Project	IEEE 802.16 Broadband Wireless Access Working Group < http://ieee802.org/16 >	
Title	Text fixing on master/slave cell terminology (action item from Session #46) + additional editorial changes	
Date Submitted	2007-11-12	
Source(s)	David Grandblaise Motorola Labs Parc Les Algorithmes Commune de Saint Aubin 91193 Gif sur Yvette, France	Voice: +33 (0)1 6935 2582 Fax: +33 (0)1 6935 4801 mailto: david.grandblaise@motorola.com
Re:	Working Group Letter Ballot #24 for IEEE P80216h/D1	
Abstract	This contribution proposes editorial changes related to the comments #83 and #87 [2] + some additional editorial changes in subclauses 6.3.2.3.64, 6.3.2.3.65, 6.3.2.3.66 and 15.4.2.5.6 of the draft [1].	
Purpose	Text fixing on master/Slave BS terminology + additional editorial changes	
Notice	This document has been prepared to assist IEEE 802.16. It is offered as a basis for discussion and is not binding on the contributing individual(s) or organization(s). The material in this document is subject to change in form and content after further study. The contributor(s) reserve(s) the right to add, amend or withdraw material contained herein.

Text fixing on master/slave cell terminology (action i

Figure h55—Master-Slave BS communication through the backhaul

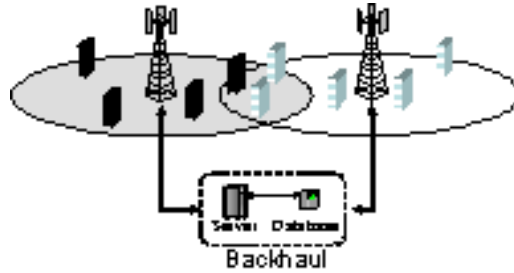
After step 3, the slave BS knows the IP_Proxy_address_M (Section 6.3.2.3.64) associated to the master [systemcell](#). Accordingly, the communications between master and slave [systemcells](#) (BSs) is performed through the backhaul to make the negotiation (*Master-Slave BS communication through the backhaul*) with the co-existence protocol (CXP). The remaining phases of the credit tokens based negotiation cycle is performed via this backhaul with IP based communications using server(s) and database(s).

Figure h58—Master BS - Slave BS communication through the backhaul

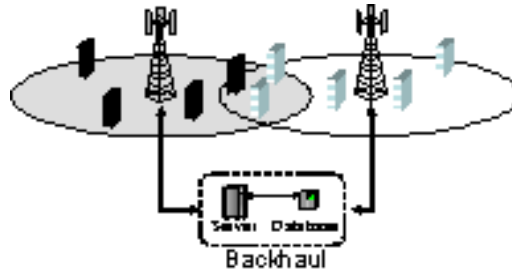
After step 2, the master BS knows the IP_Proxy_address_S (Section 6.3.2.3.65) of the slave [systemeell](#). Accordingly, the communications between master and slave [systemeells](#) (BSs) is performed through the backhaul to make the negotiation (*Master BS - Slave BS communication through the backhaul*) with the co-existence protocol (CXP). The remaining phases of the credit tokens based negotiation cycle is performed via this backhaul with IP based communications using a server and database.
